RHODE ISLAND  
DEPARTMENT OF ENVIRONMENTAL MANAGEMENT

25 June 1997

RE: Addendum to the Sites 03 and 09 Phase III Work Plan  
Offshore Geotechnical Sampling and Confirmation Study at Site 09  
NCBC Davisville, Rhode Island  
Submitted 14 May 1997, Dated 12 May 1997

# FIG. 1

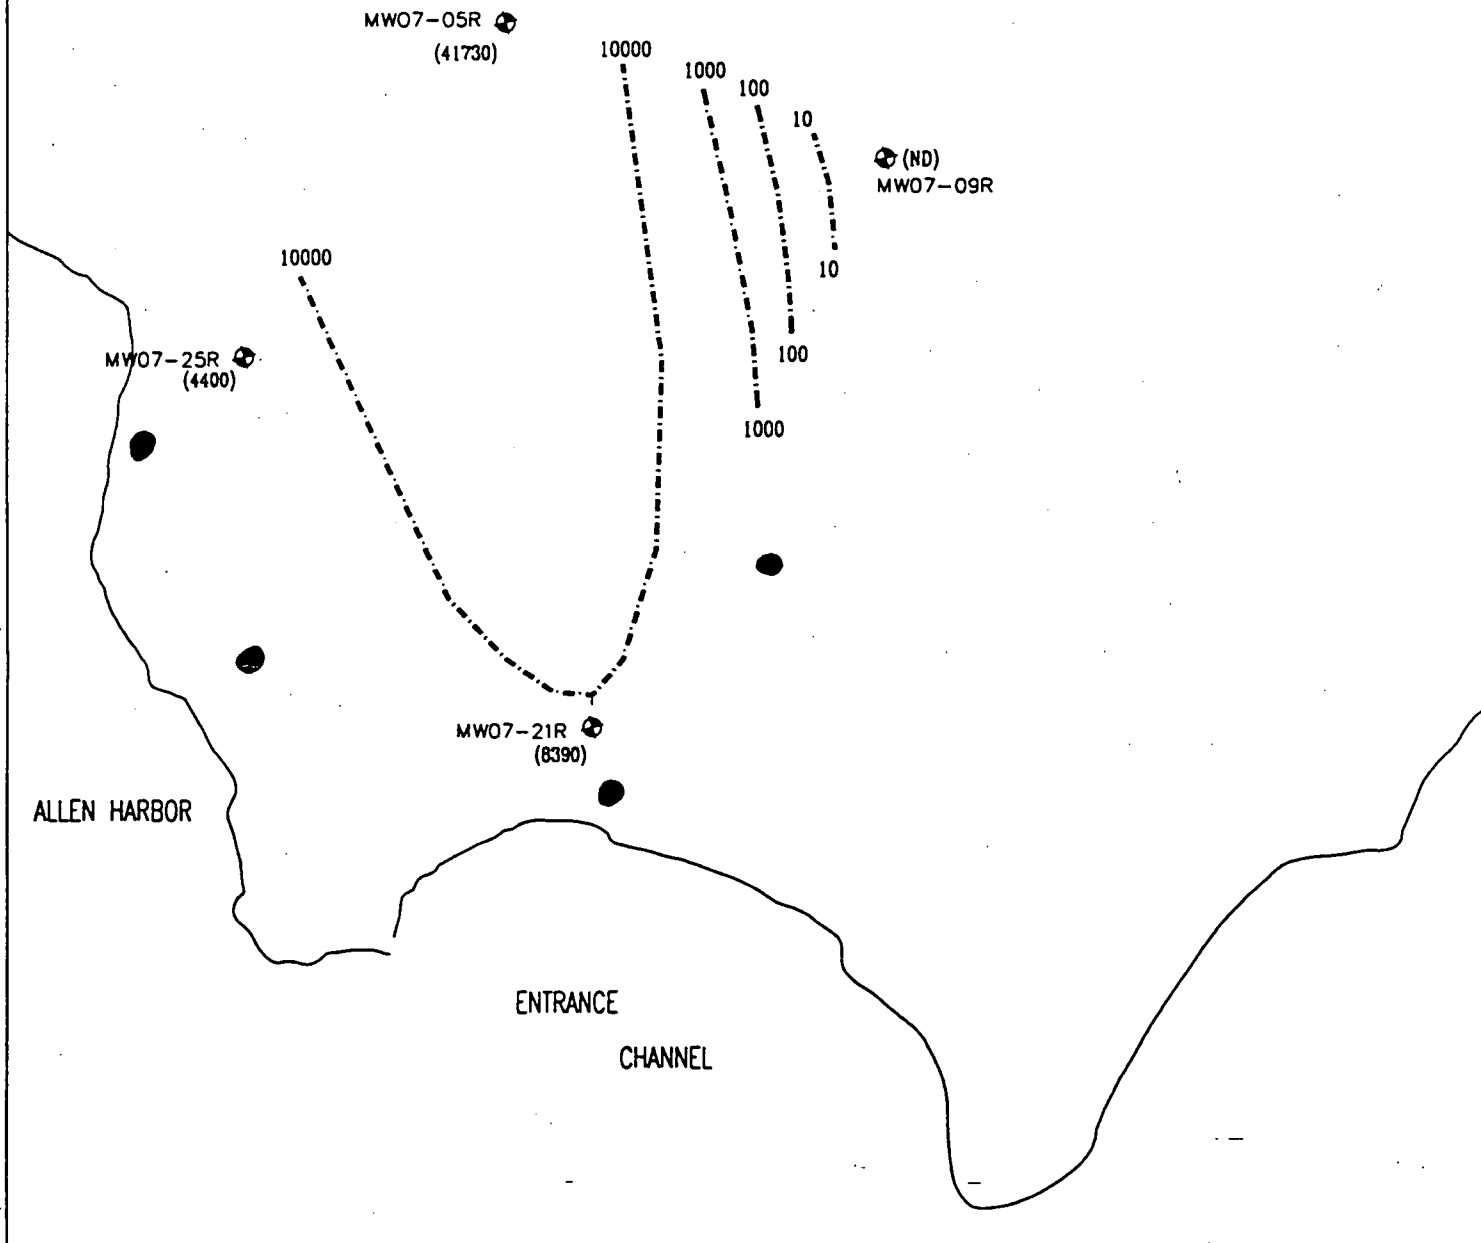
As noted in RIDEM's 19 June 1997 comments, on the above referenced workplan, it was requested that additional borings in Allen Harbor be advanced to bedrock to validate the model used to predict fate and transport of COCs. In addition, these borings can provide information regarding possible plume migration from Calf Pasture Point. As noted in comment # 2, RIDEM is suggesting possible locations where additional borings should be placed.

In order to verify the model presented for the Allen Harbor Landfill it is necessary to determine if the hydrogeology within Allen Harbor is contiguous with that under the landfill. Therefore, bedrock topography mapping would be helpful in verifying the model. Similar to the 13 borings proposed along Allen Harbor Landfill (which have been requested to go to bedrock) it is also requested that an additional five to borings be placed along the perimeter of Calf Pasture Point and the Allen Harbor channel as shown in Figure 2. This would provide the Navy with the data necessary to verify the model, but would also further define the bedrock groundwater plume migration toward and into Allen Harbor.
